Subject: Fuel Criterion Evaluation Process (FCEP) Notification of the Standardized Debris Filter Bottom Nozzle (SDFBN) Design (Proprietary/Non-Proprietary)

**Fuel Criterion Evaluation Process (FCEP) Notification of the Standardized
Debris Filter Bottom Nozzle (SDFBN) Design (Non-Proprietary)**

Notification of Change to the Standardized Debris Filter Bottom Nozzle (SDFBN) Design

Figure 1: Current 17x17 DFBN

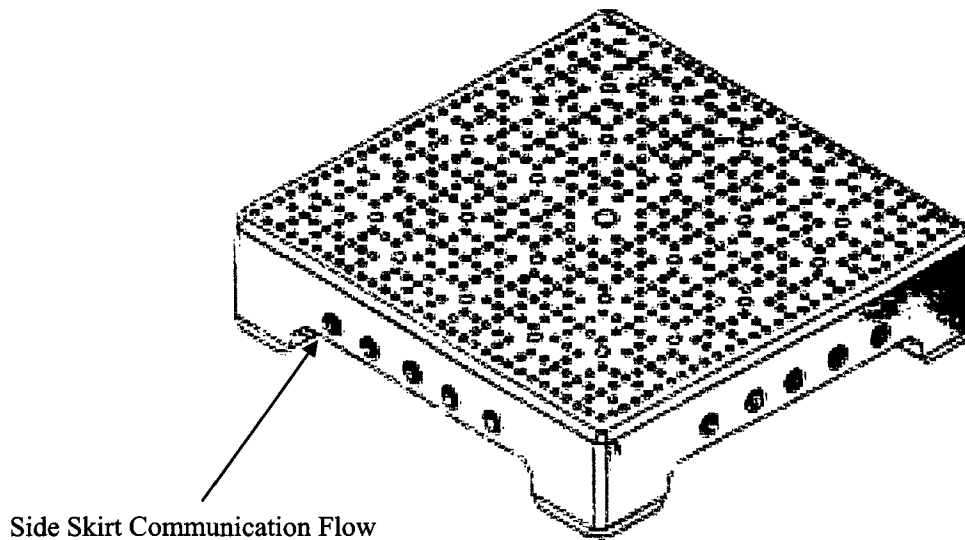
Included in the design of the SDFBN is a chamfer on the inlet and outlet of the flow holes, as well as the elimination of the side skirt communication flow holes. The flow holes can be seen on the skirt of the DFBN in Figure 1. The current DFBN only has a chamfer on the inlet of the nozzle. The SDFBN includes an inlet and outlet chamfer as shown in Figure 2.

Figure 2: General Comparison of Current 17x17 DFBN and SDFBN Flow Hole Geometries

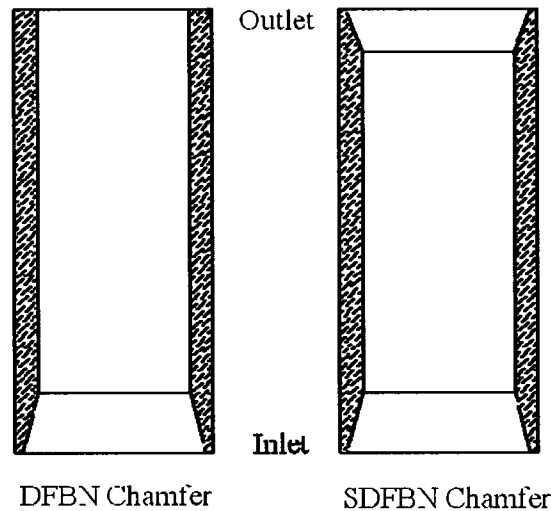
Westinghouse is pursuing the standardization of these nozzles (Standardized DFBN - SDFBN) such that bottom nozzles provided by any qualified supplier will have a loss coefficient consistent with that of the Jedinstvo DFBN. The SDFBN design specifies precise flow hole outlet chamfer geometry such that a consistent pressure drop will result regardless of the supplier.
